Technical Service Bulletin

NUMBER: 09-08-99

THIS BULLETIN SUPERSEDES TECHNICAL SERVICE BULLETIN 09-05-98, DATED NOV. 6, 1998, WHICH SHOULD BE REMOVED FROM YOUR FILES AND NOTED IN THE 1998 TECHNICAL SERVICE BULLETIN MANUAL (PUBLICATION NO. 81-699-99003). ALL REVISIONS ARE HIGHLIGHTED WITH **ASTERISKS AND INCLUDE PART NUMBER REVISIONS AND MODEL ADDITIONS.**

Multi-Layer Steel (MLS) Head Gasket Installation Procedures

FIGURE 1

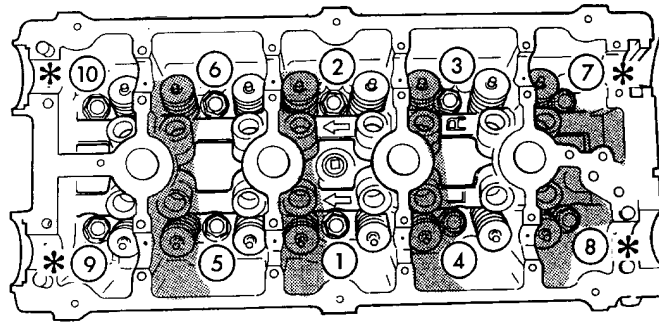
NOTE: THE 2.0L DOHC TORQUE AND TORQUEING PROCEDURE HAS CHANGED WITH THE INSTALLATION OF A MLS GASKET. USE THE FOLLOWING PROCEDURES FOR THE 2.0L DOHC ONLY.

2.0L DOHC TORQUE PROCEDURE WITH MLS GASKET INSTALLATION

NOTE: THE 4 SHORT BOLTS ARE PLACED IN THE CORNERS.

- A. Torque all center bolts to 34 Nm (25 Ft Lbs), Torque the 4 corner bolts to 27 Nm (20 Ft Lbs) see Fig 1 for torque sequence.
- B. Torque all center bolts to 68 Nm (50 Ft Lbs), Torque the 4 corner bolts to 47 Nm (35 Ft Lbs) see Fig 1 for torque sequence.
- C. Re-torque all center bolts to 68 Nm (50 Ft Lbs), Re-torque the 4 corner bolts to 47 Nm (35 Ft Lbs) see Fig 1 for torque sequence.
- D. Tighten all bolts in the specified sequence (Fig 1) an additional 90° (1/4 turn).

* LOCATION OF 110 mm (4.330 in.) BOLTS 9509-243
